AGENDA
PLANNING AND ZONING COMMISSION MEETING
CITY OF CREVE COEUR, MISSOURI
MONDAY, MAY 1, 2017

**APPLICATION TO PLANNING AND ZONING COMMISSION
#17-014 FOR A MINOR SITE PLAN APPROVAL FOR NEW EXTERIOR
LED LIGHTING AT SPOEDE ELEMENTARY SCHOOL,
AT 425 N. SPOEDE ROAD**

APPLICATION TO PLANNING AND ZONING COMMISSION #17-015 A MINOR SITE DEVELOPMENT PLAN FOR A FENCE WITHIN THE FRONT-YARD SETBACK ALONG MASON ROAD FOR THE PROPERTY AT 12700 CREEKSIDE VIEW DRIVE

APPLICATION TO PLANNING AND ZONING COMMISSION
#17-016 A MINOR SITE PLAN FOR WING WALLS ON EITHER SIDE OF
THE DRIVEWAY ENTRANCE WITHIN THE FRONT-YARD SETBACK
FOR THE PROPERTY AT 11705 LAKESHORE DRIVE

Description: View looking at the front of Spoede School at the existing non-conforming lights on the building.

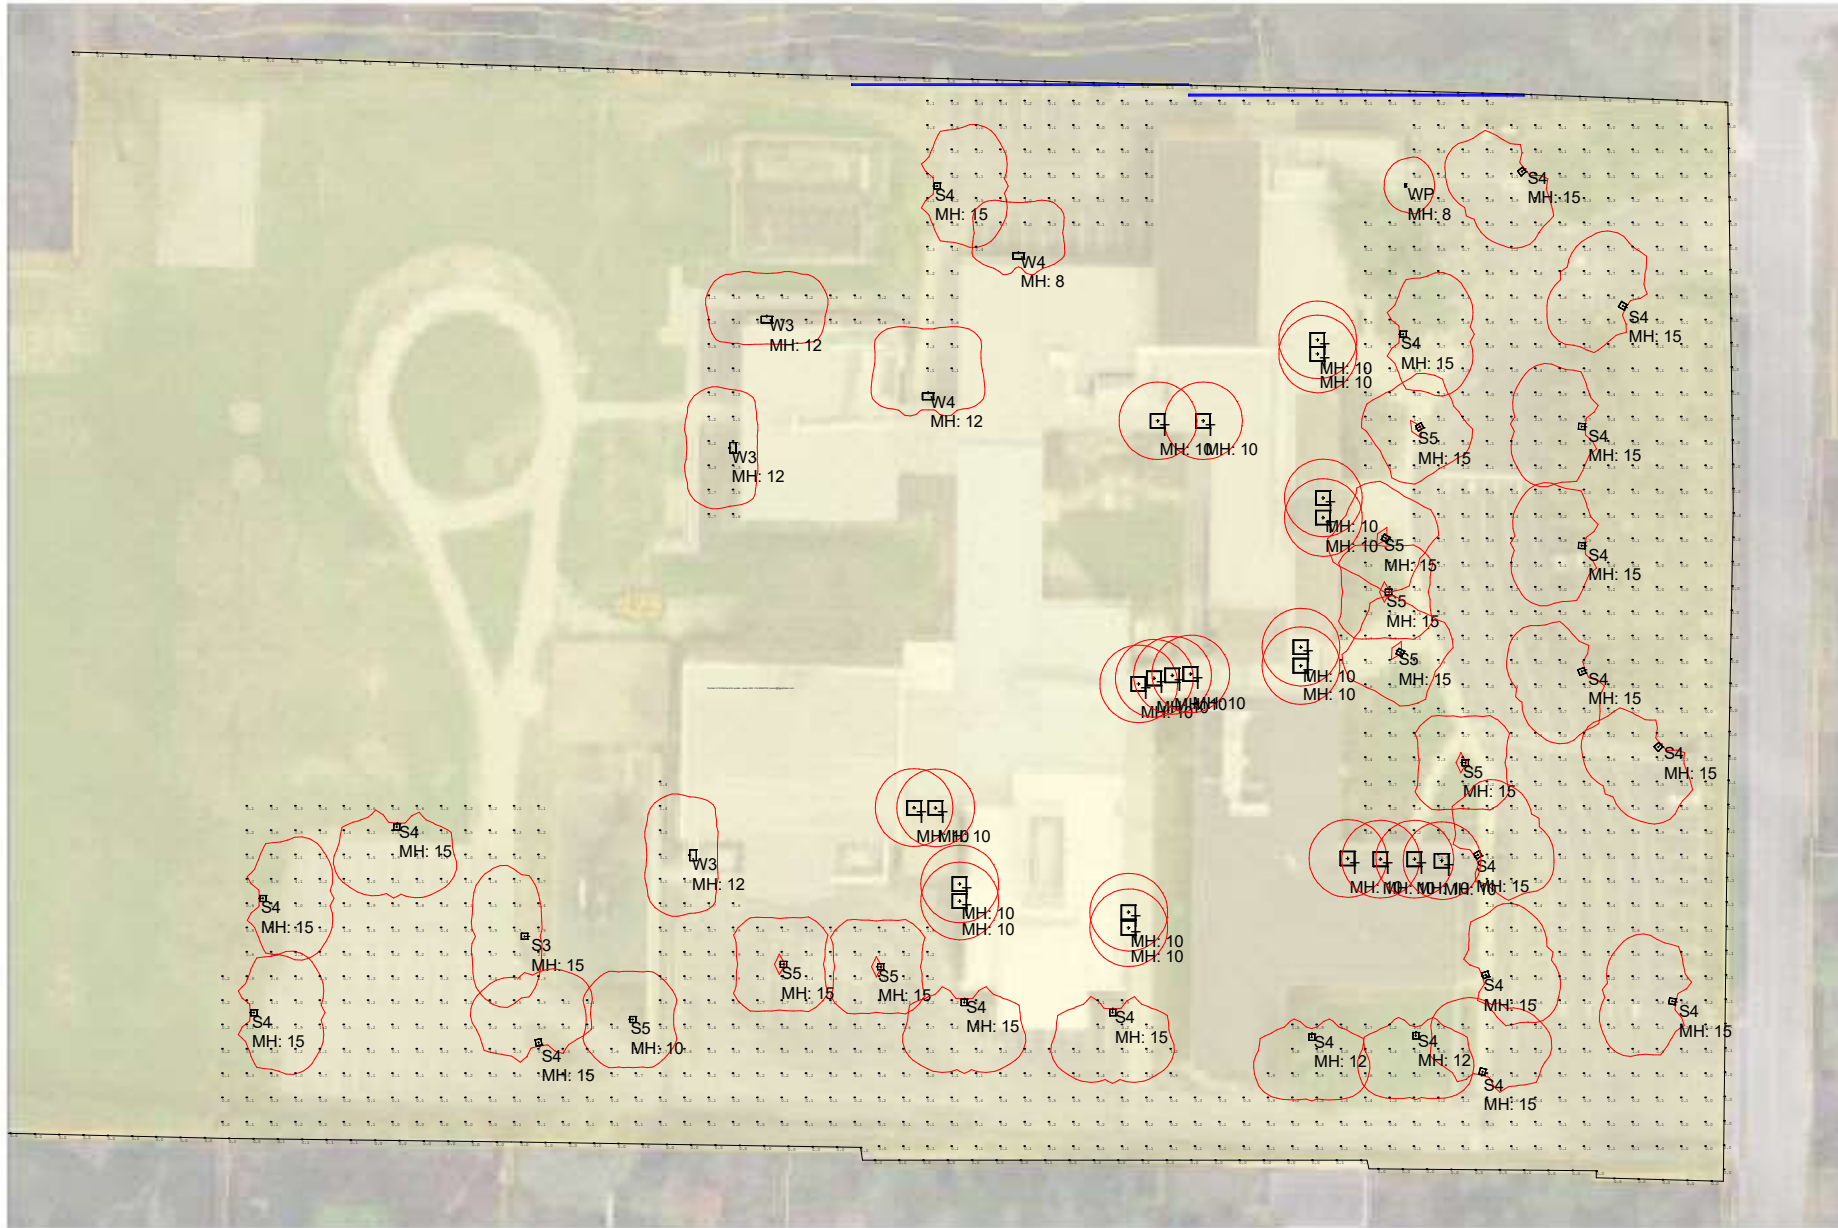
The Ladue School District is seeking to replace the non-conforming light fixtures on the building that shine outward, with new LED fixtures throughout the site, including new pole fixtures and building fixtures, that are consistent with the City's regulation that all lighting is downcast and that no lighting is cast upon the adjacent property.

Figure 1: Close-up of the Applicant's Site Plan with the proposed fence line along Mason Road highlighted.

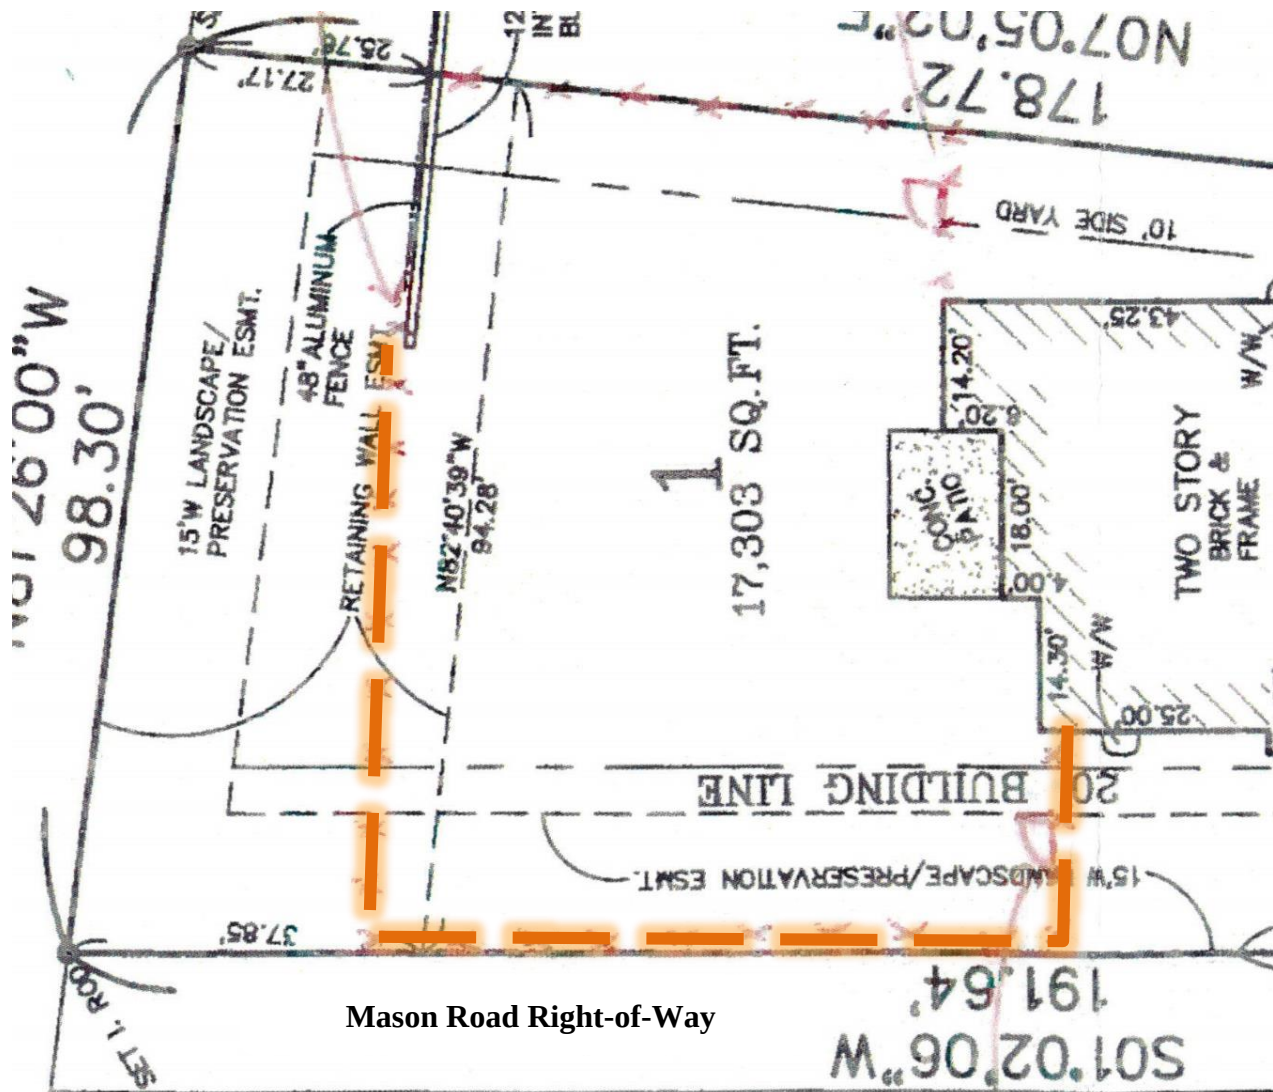
The proposed fence would be a four foot tall, black metal open slatted fence along east property line along Mason Road, just west of the sidewalk, and then connecting with the existing guardrail on the south west portion of the property to enclose the yard.

Staff recommends placing the fence on the property side of the 15 foot Landscape/preservation easement, per the image below. Moving the fence to this location would allow the fence to be located behind the row of street trees along Mason Road to preserve the view of the landscaping along Mason Road which was required as part of the subdivision approval. This change would also further the proposal toward the objective of the Comprehensive Plan to maintain open vistas. The fence at the 15 foot setback would also be consistent with the regulation allowing such fences as swimming pool barriers, per Building Code regulations, provided it is 15 feet from the property line. Staff has included the 15 foot setback within the recommended draft motion. If the Commission wishes to allow for something between the property line and the 15 foot setback, direction should be provided to the Applicant and the motion modified for such included with the approval.

"I move to approve the site plan for the four-foot tall, open-slatted black metal fence, 15 feet from the east property line along N. Mason Road for the property addressed as 12700 Creekside View Dr. as discussed within the Staff Report on Application #17-015 for the May 1, 2017 Planning and Zoning Commission" (conditions may be added by separate motion).

Figure 1: Close-up of the Applicant's Site Plan with the proposed walls highlighted in yellow.

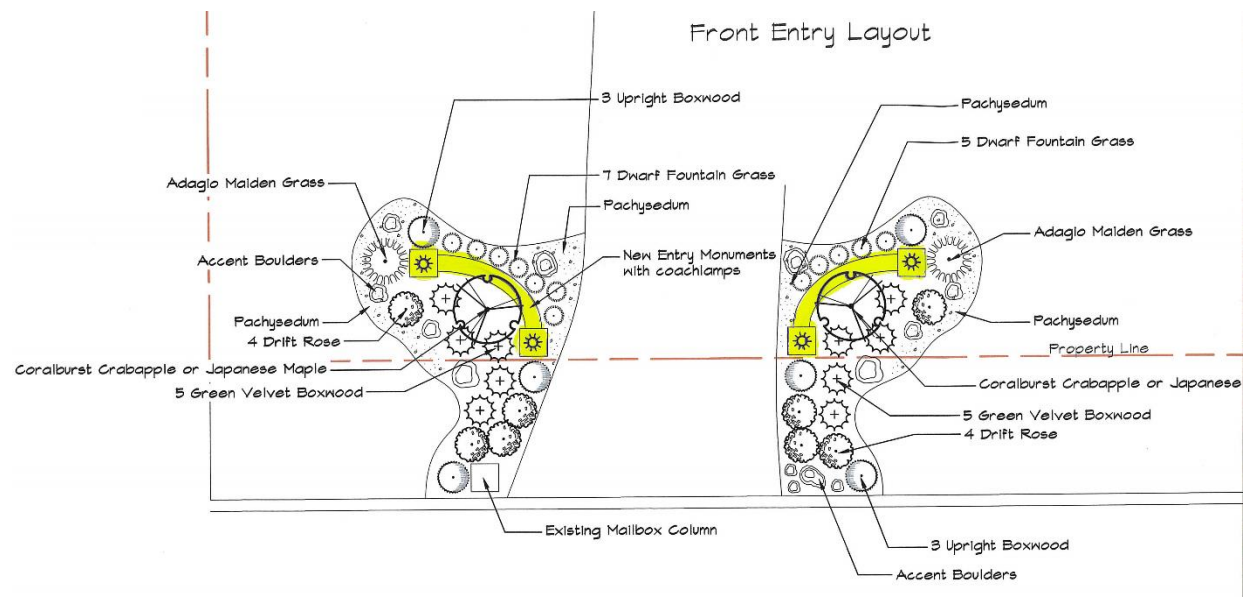
The proposed wing walls are on either side of the driveway at the property line, approximately 10 feet from Lakeshore Drive. The walls are five-feet tall with a curve approximately 12 feet in width along the centerline with decorative gaslights at either end and a mix of CMU masonry piers with stone and brick veneer to match the existing home. Landscaping surrounding the walls will soften the appearance.

Further, the Design Guidelines recommend the use of natural “green” materials, and discourage the use of synthetic, and highly reflective materials. The proposed wall design is in keeping with the architectural style of the main home, and provides for a mix of materials, and landscaping to soften the structures. However, they are free standing away from any natural break in the terrain, and from the building. Further it would appear out of character with the rest of the neighborhood, where no other similar structures are found, as noted in the public comment received from the Subdivision Trustees. Whether or not these wall features in this area represent an incremental change or a step too far in the wrong direction is largely a matter of visual preference and consideration of the design details, and location. While the City cannot enforce the subdivision indentures, it may take them into consideration as part of their review. It is important to note that 405.630(A)(7) of the Yard Regulations allows for ornamental entry columns and gates within required yards, without review, where the gate is the movable frame or solid structure which swings, slides, or rolls controlling ingress and egress through an opening in a fence, wall or vegetation, and the column is the pillar connected to the gate. It is the walls expanding from the column that requires the Planning and Zoning Commission review under

"I move to approve the site plan for two, five-foot tall, 12 feet long curved wing walls on either side of the driveway at the front property line within the front-yard setback for 11705 Lakeshore Drive as discussed within the Staff Report on Application #17-016 for the May 1, 2017 Planning and Zoning Commission" (conditions may be added by separate motion).

Figure 2: Close-up of the Applicant's Civil Grading Plan for the new stadium.

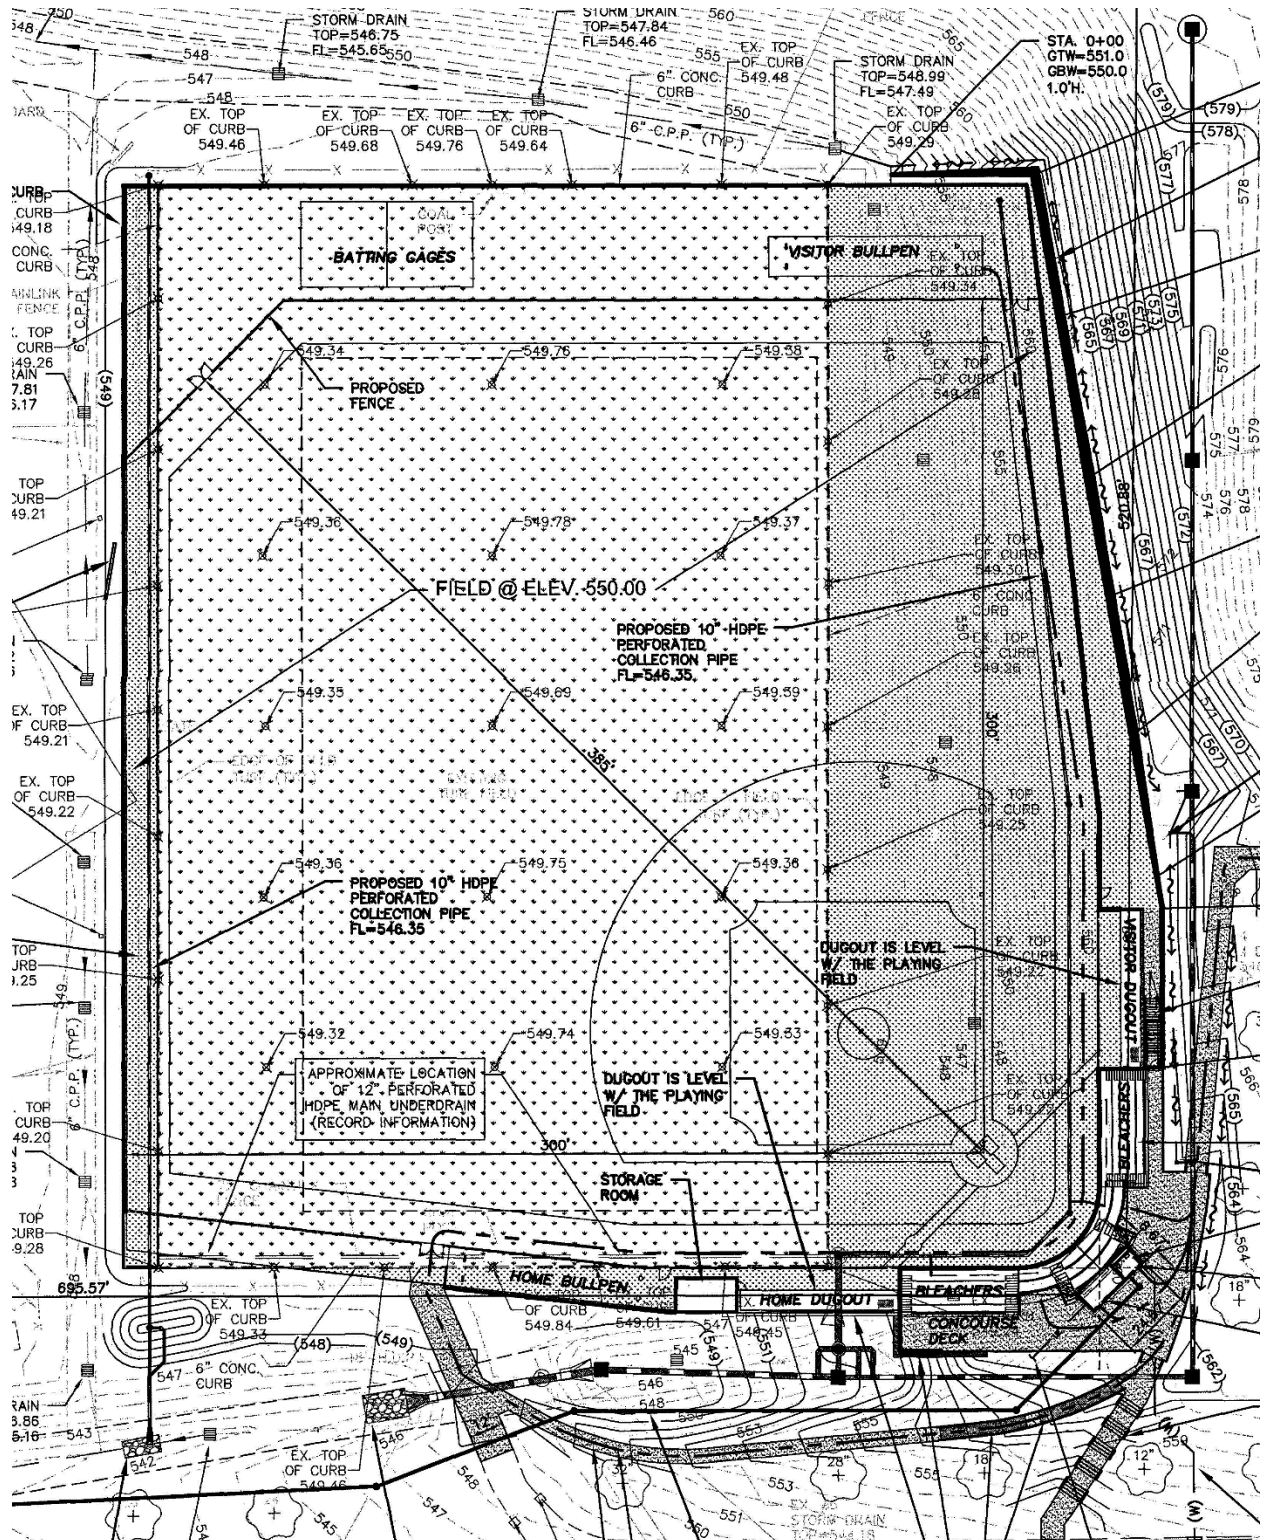
The proposed field and stadium will utilize the existing hillside grade for the seating, where the northeast retaining wall corner is 140 feet from the north property line.

The civil drawings indicate that the site coverage is 27%, where Section 405.250(E)(3)(e) has a required maximum site coverage of 25%. The Applicant submitted a letter indicating that the proposed site coverage is at 23%. Therefore, a condition of approval has been included that the revised drawings indicate the correct site coverage for the campus with a maximum of 25%.

Figure 6: Close-up of the Overall Site Plan showing available parking for the Stadium

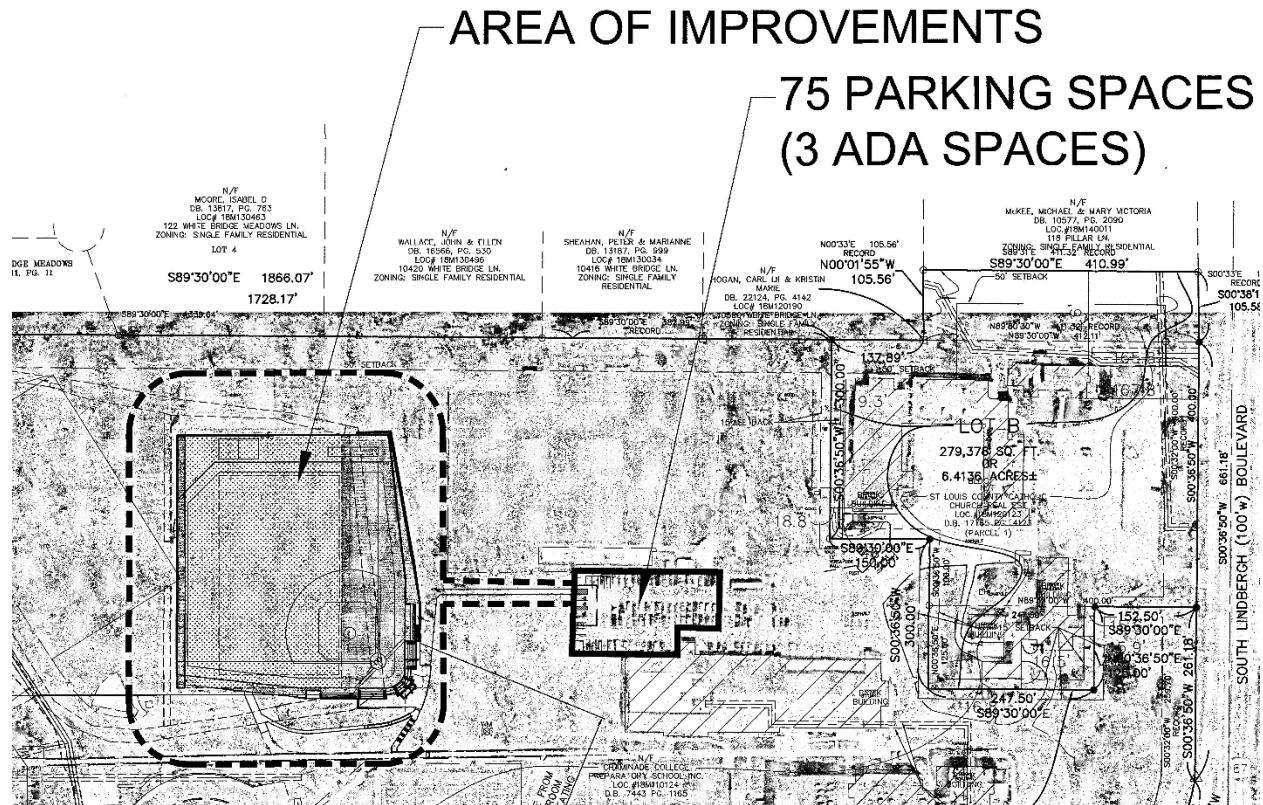
Parking will be provided within the existing facilities on site, with a new accessible path from the north parking lot to the stadium which is included in the proposal.
